Model: S-C3		Date: 5-Mar-07	No.: MB262001
Modified Article: SD card cover		Prepared by: Y. Yoshida	
From: 1st Tech. Support Sec. Service Support Dept.			
Reason for Modification:	☐ Parts catalog correction ☐ Vendor change ☐ Other ☐ To facilitate assembly ☒ To improve reliability ☐ To meet standards (RoHs compliant) ☐ Part standardization ☐ Product Safety

Model: S-C3		Date: 21-Jun-07	No.: MB262002
Modified Article: Operation panel		Prepared by: Y. Yoshida	
From: 1st Tech. Support Sec. Service Support Dept.			
Reason for Modification:	☒ Parts catalog correction	☐ Vendor change	☐ Other
	☐ To facilitate assembly	☐ To improve reliability	☐ To meet standards (RoHs compliant)
	☐ Part standardization	☐ Product Safety

Part Change Information List

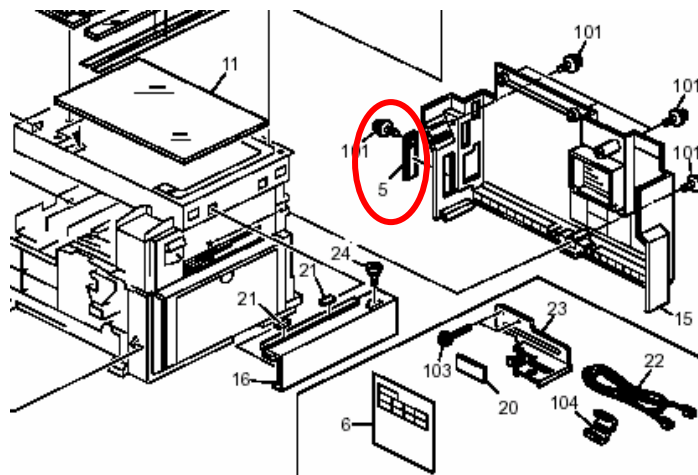
Change: The shape of the part was changed.

Reason: To further ensure that the SD card stays locked in place.

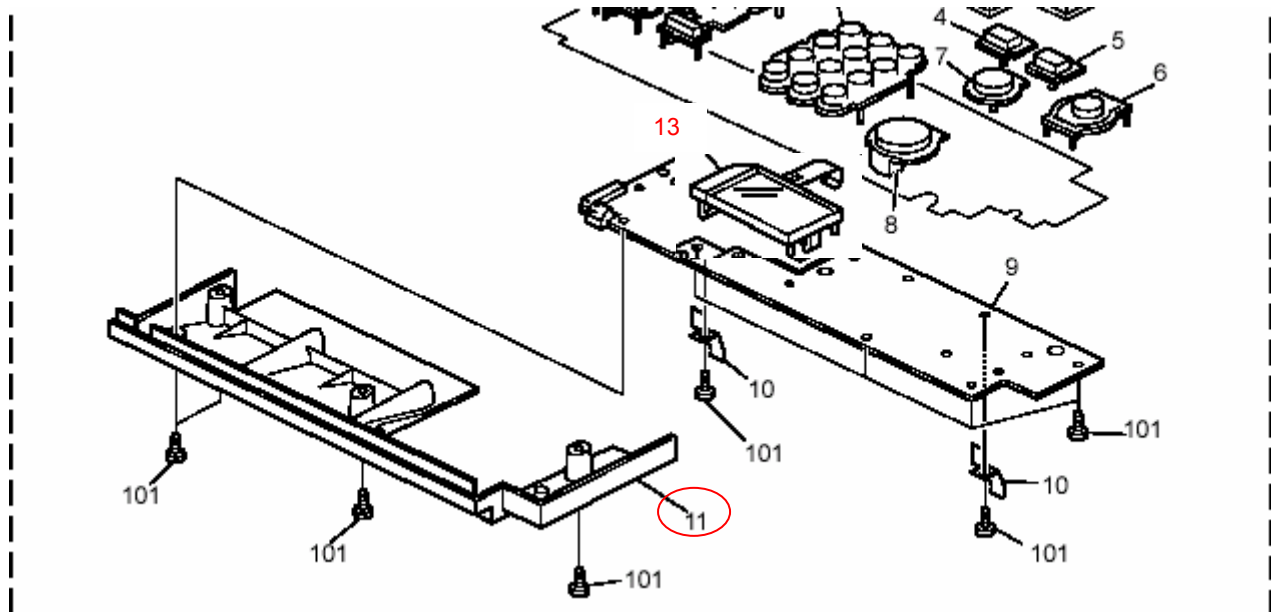
Change/Reason: The index numbers of the following parts were corrected.

Part number	Description	Q'ty	Int	Page	Old index	New Index	Note
B2621452	Lower Cover	1		8	NA	11	
B2621495	LCD	1		8	11	13

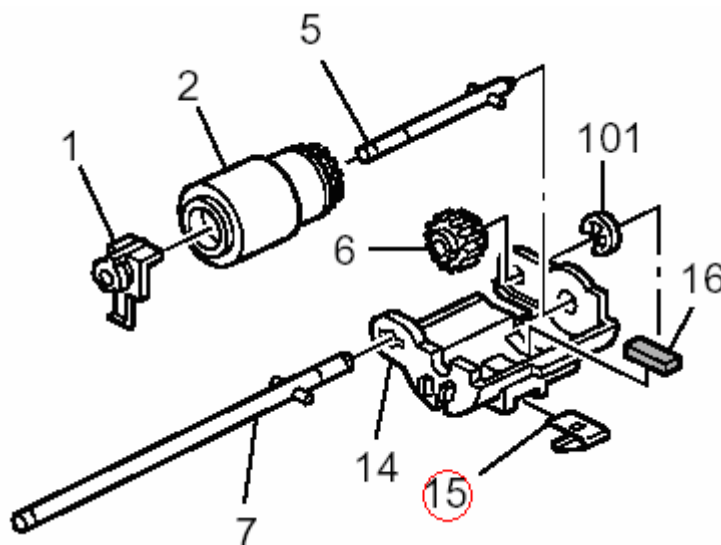
Change: The thickness of the spring plate was reduced from 0.2 mm to 0.15 mm (which reduces the spring pressure).

Reason: To further ensure that multi-feeds do not occur.

- Difference between the old and new parts: The new part has two small holes.
- This MB will be reissued later to announce the cut-in serial numbers for this change.

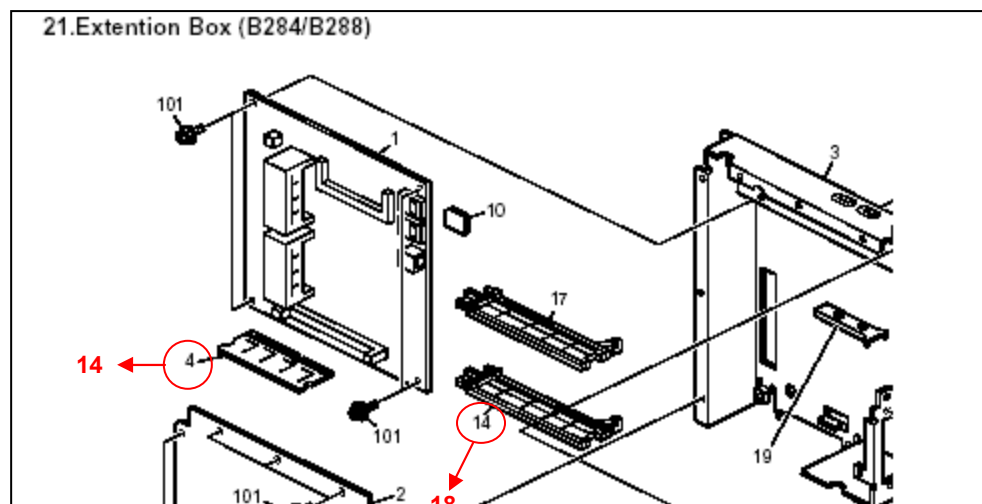
Change/Reason: The index numbers of the following parts were corrected.

Part number	Description	Q'ty	Int	Page	Old index	New Index	Note
G3325730	PCB:Sdramdimm:256mb:Chn:Ass'y	1		46	4	14	
B6225832	Rail:Left	1		46	14	18

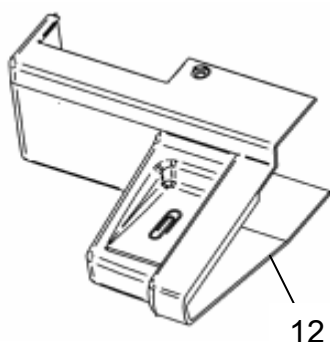
Part Number	Description	Q'ty	Int	Page	Incorrect Index	Correct Index	Note
B2621473	Cover: Fax: Dummy	1		9	1	12

Change/Reason: The index for this part was corrected as shown.

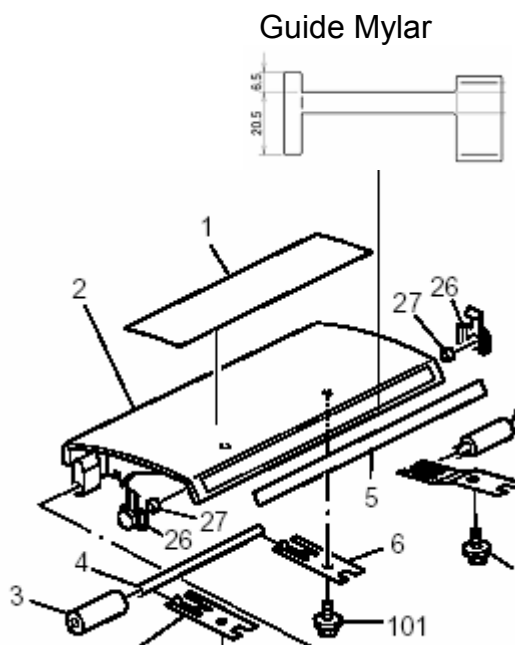
Change/Reason: The following part was missing from the parts catalog.

Part number	Description	Q'ty	Int	Page	Old index	New Index	Note
B8724712	Guide Mylar	1		3		30	New(B872 P/C)
B8724712	Guide Mylar			19		30	New(B292 P/C)
B8724712	Guide Mylar			19		23	New(B284/B288 P/C)

7.ARDF 1 (B292)

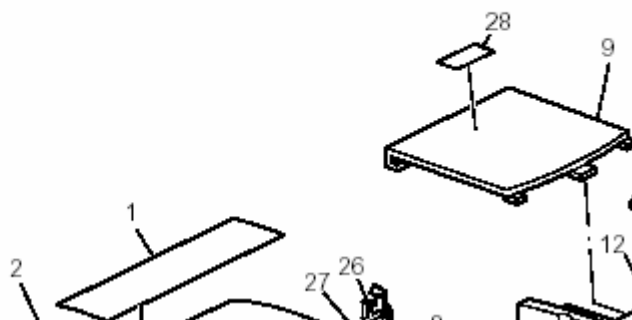
Incorrect part number	Correct part number	Description	Q'ty	Int	Page	Index	Note
B8592352	A8592352	Pressure Plate Pad	1-1	-	19	28
